Date: 12-21-07

FIELD BULLETIN

FIGURE 1 – COIN MECH IMPROPERLY INSTALLED – THE PIN ON THE COIN MECH IS NOT PROTRUDING THROUGH THE HOLE IN THE METAL BRACKET

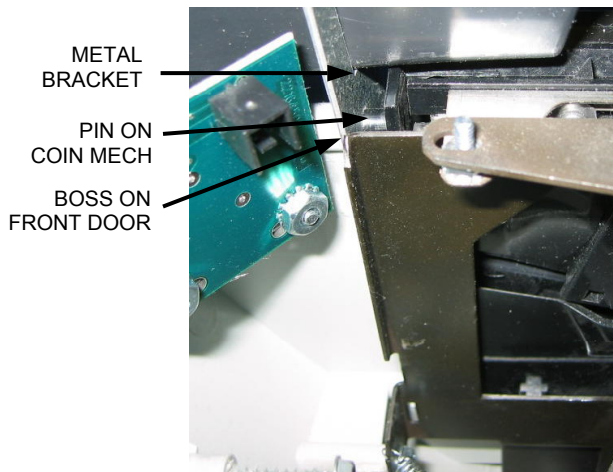
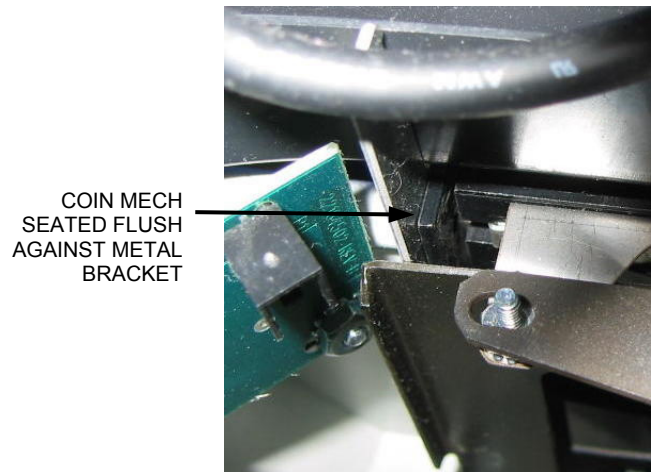
- Issue:** Some MoD BoX jukeboxes were built with the coin acceptor installed incorrectly.
- Games affected:** Only MoD BoX jukeboxes are affected.
- Symptoms:** If the coin acceptor is installed incorrectly, coin jams may occur.
- Solution:** If your MoD BoX is experiencing coin jams, follow the instructions below to check the seating of the coin mech.

3. Using Figures 1 and 2 below, check to see if the pin on the coin mech is properly inserted through the hole in the metal bracket and then through the hole in the door boss. If the pin on the coin mech is visible as shown in Figure 1, loosen the 3 screws securing the coin mech assembly to the door.

4. Seat the top pin on the coin acceptor into the hole in the metal bracket and then through the hole in the door boss. Seat the bottom pin on the coin mech into the hole in the door boss.

5. Make sure that the coin acceptor is sitting flat against the metal bracket, which is sitting flat against the door boss (see Figure 2).
6. While applying some pressure to hold the coin mech assembly in place, retighten the 3 screws securing the coin mech assembly.

7. Make sure that the coin acceptor is flush to the coin chute guide and door.
